Addendum No. 3

Bid / Request for Proposal Call No. T2024-220 Construction of the Fire station

This Addendum forms part of the Bid/Proposal Document.
(Question 1-95 had already been replied in Addendum 01 and 02)

- 6. A06.01 – GLAZING ELEVATIONS & SCHEDULE**
.i Delete issued for Tender drawing A06.01 in its entirety and substitute drawing A06.01 barring revision 9 appended to this document.

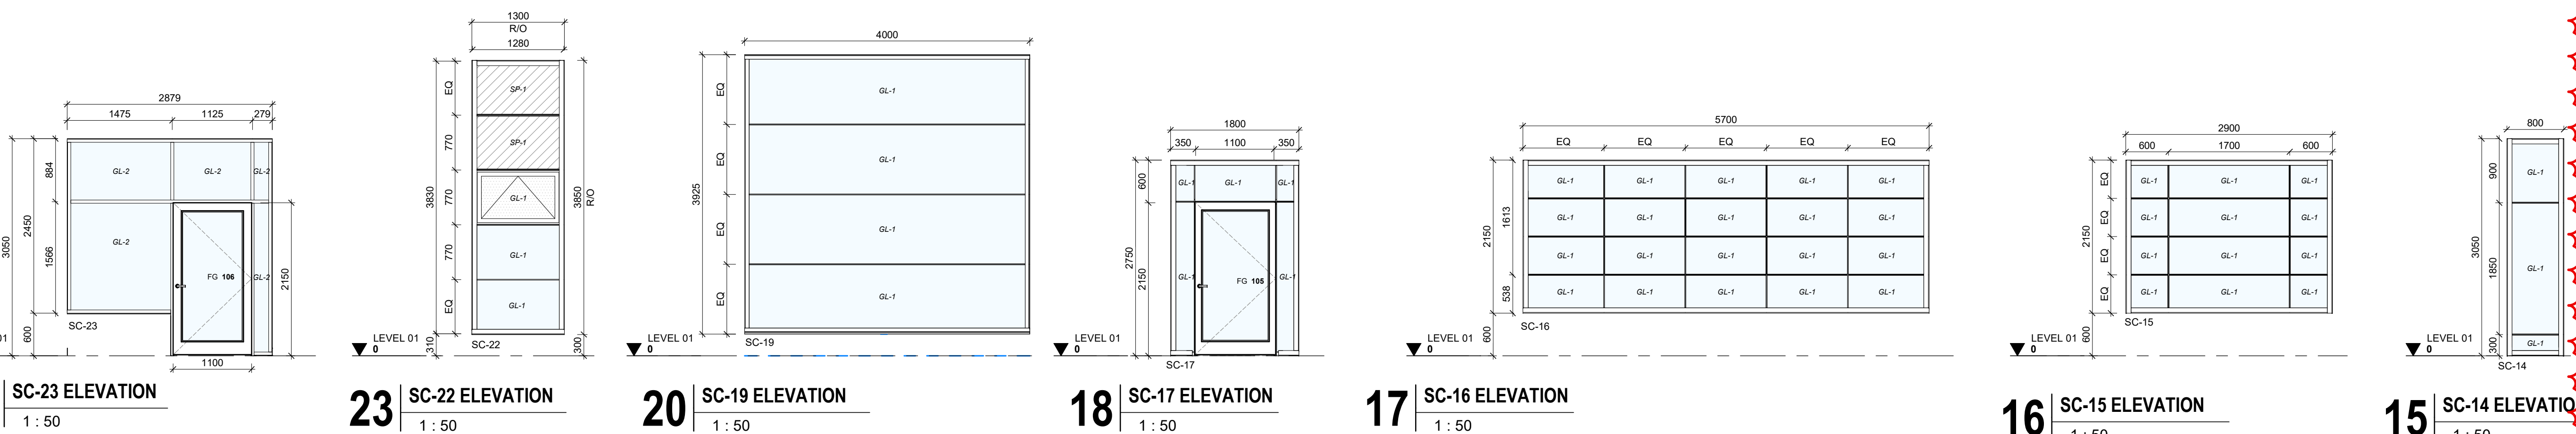
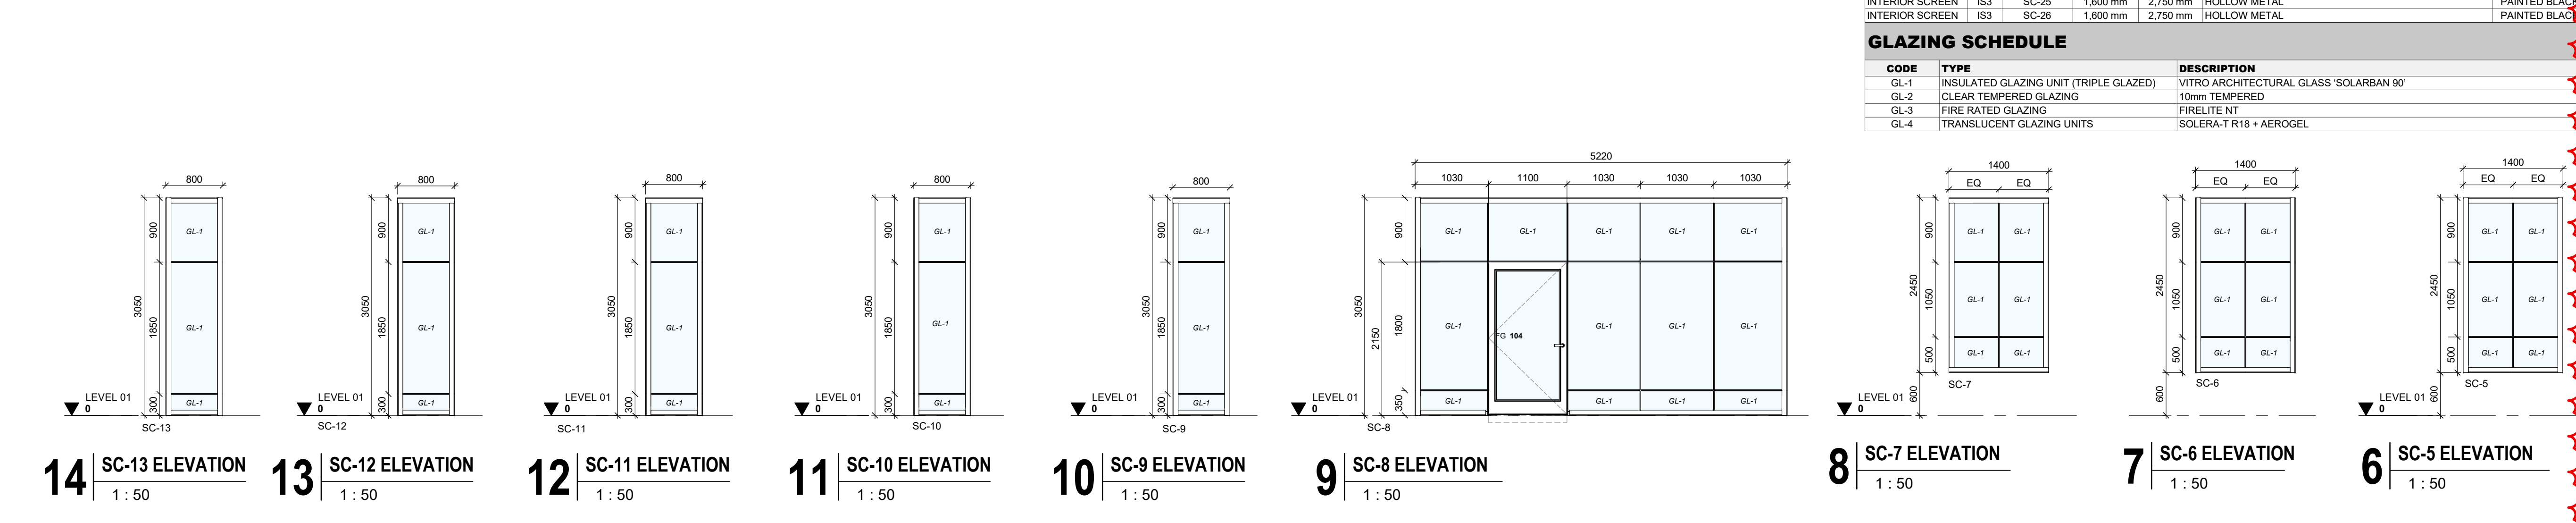
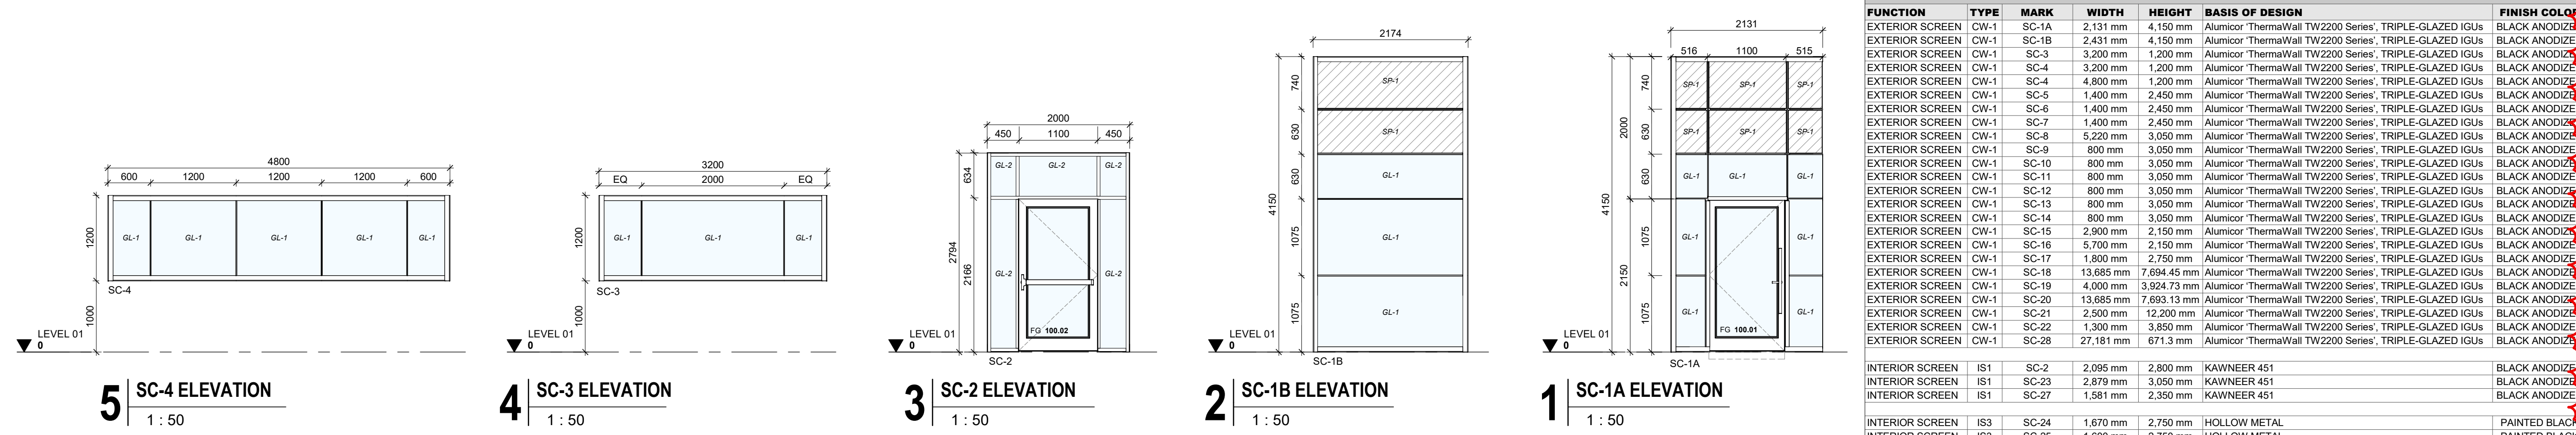
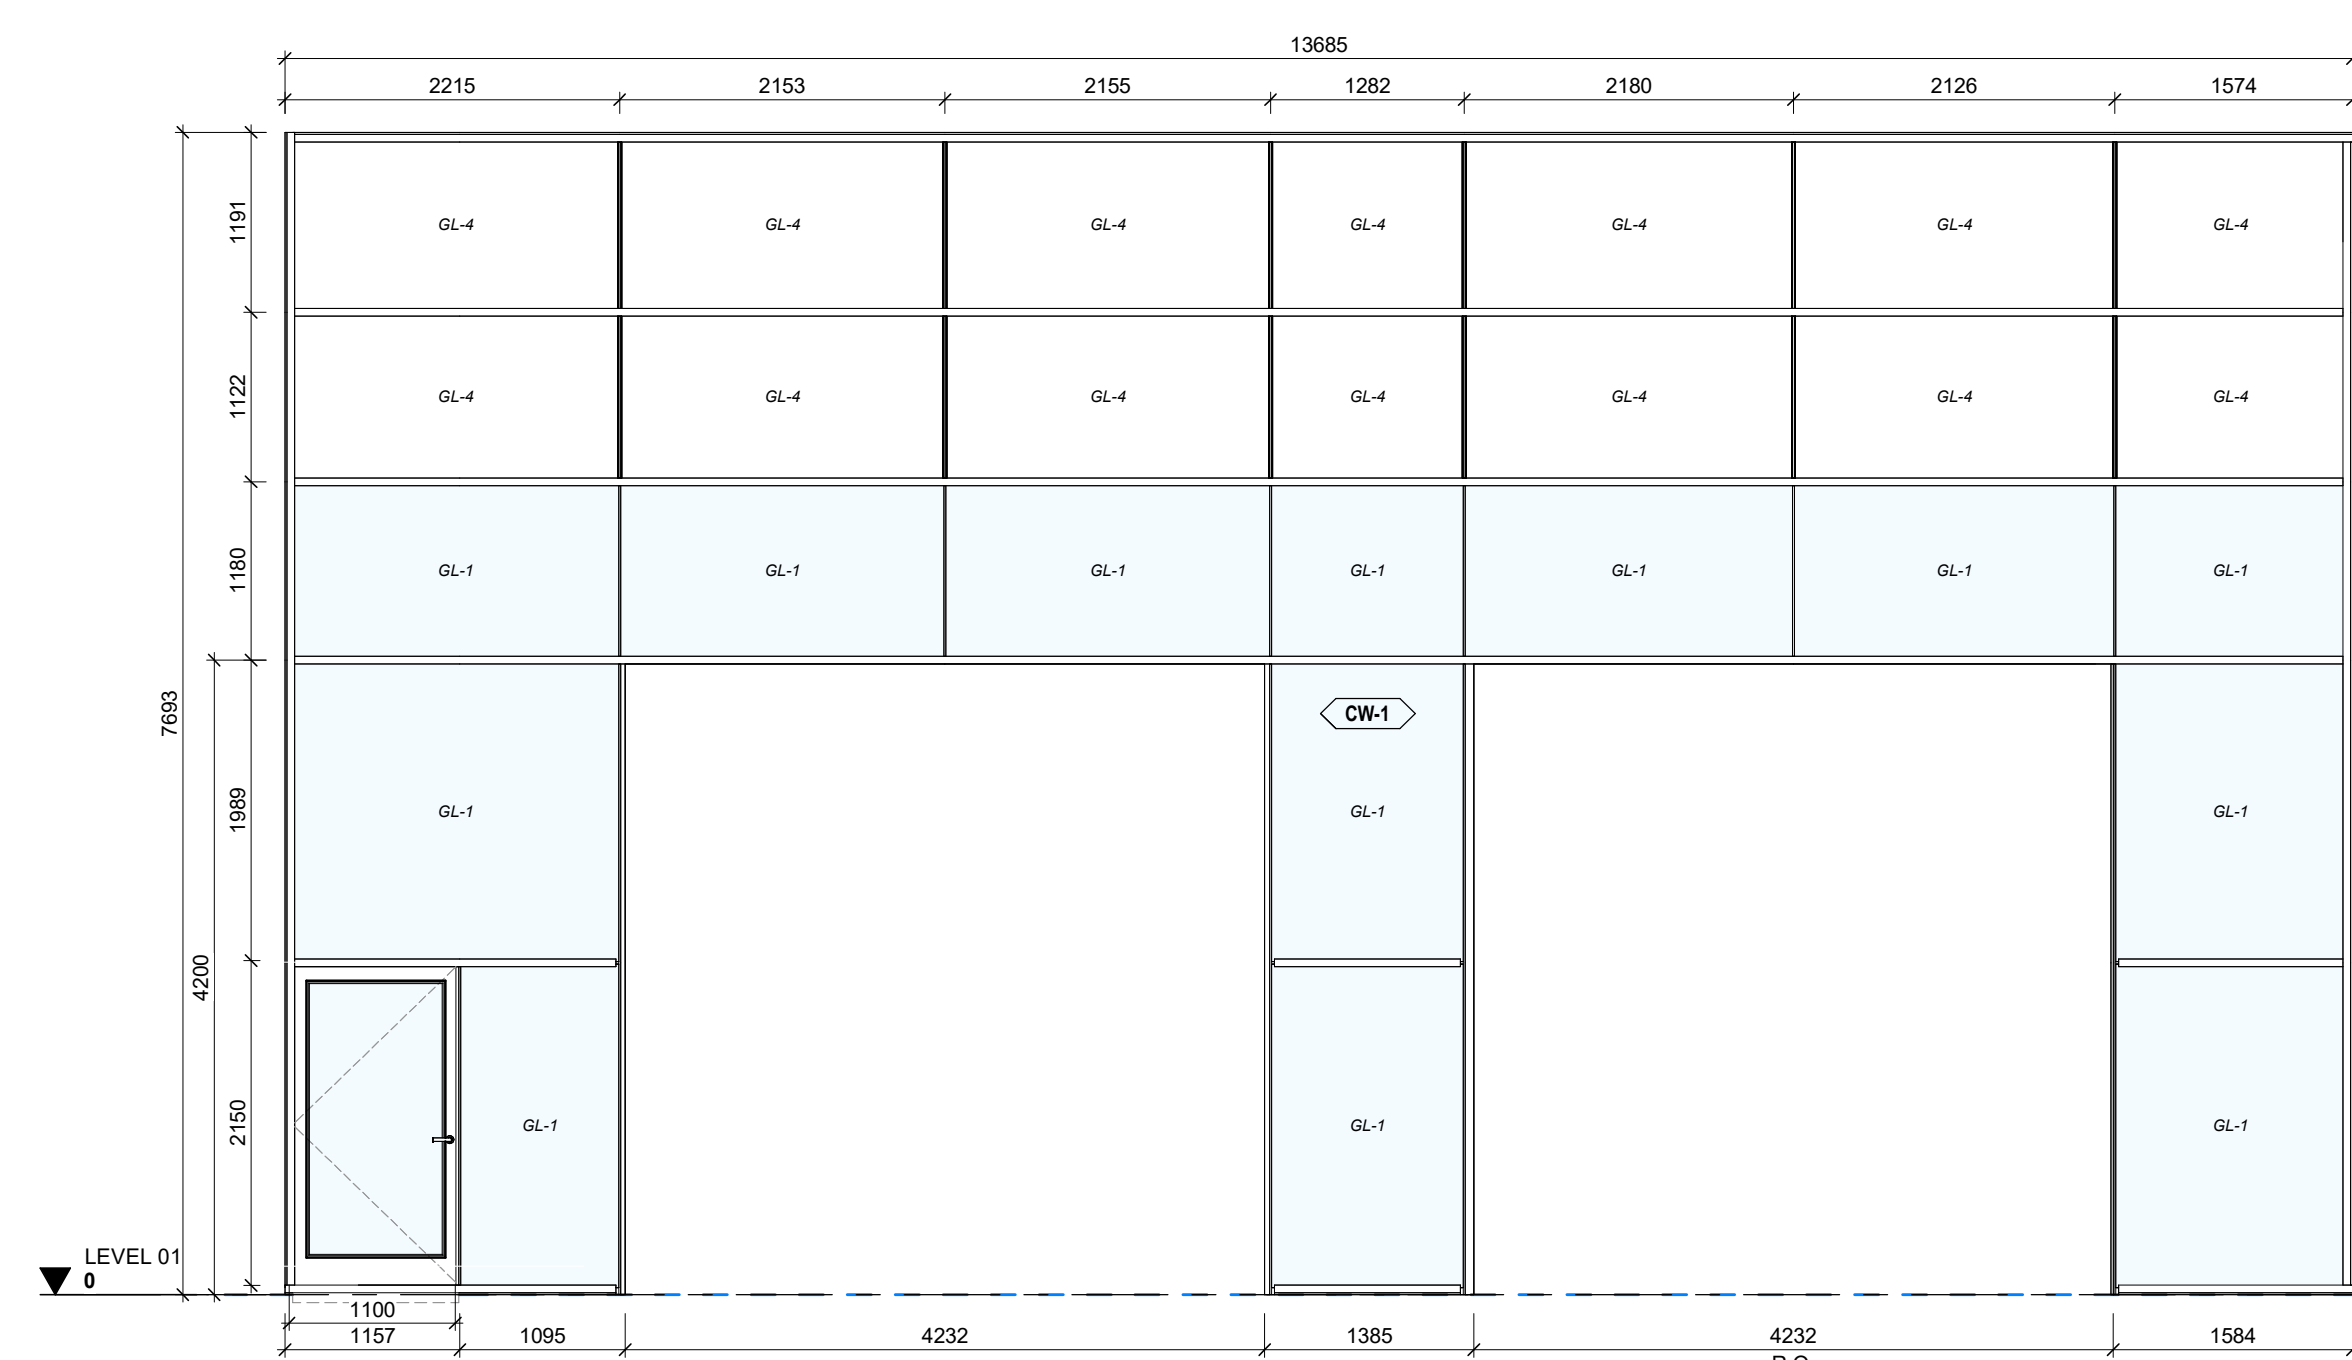
Some like SC-10 seem to be doubled up and SC 30 is not shown. The double up ones only have 1 on plans and elevations of the building so wondering what is going on here.

1. I am looking for more curtain wall plan and section details, I wanted to know if SC18 and SC20 have fastening points midway. 2inch frame might not pass wind load if there is none.
2. The curtain wall system was changed from Schuco to Alumicor TW2200, and A00.03 note is calling for an 8 inch back section. TW2200's deepest back section is 5inch, please confirm if we need to change to 2600 series.
3. Specs and some parts of the drawing calls for triple pane units, but window details on A07.03 shows a double glazed system. Please confirm if there is an intention to use double pane units in some areas and please identify which ones.
4. Are we supposed to supply GL4 - Solera -T R18 Glass for SC-18 and SC-20, the wall section looks like spandrel glass with a backpan. Can we use this as an alternative instead?

Drawing A06.01 and A06.02 have been revised to clarify glazing scope.

Drawing A06.01 and A06.02 have been revised to clarify glazing scope.
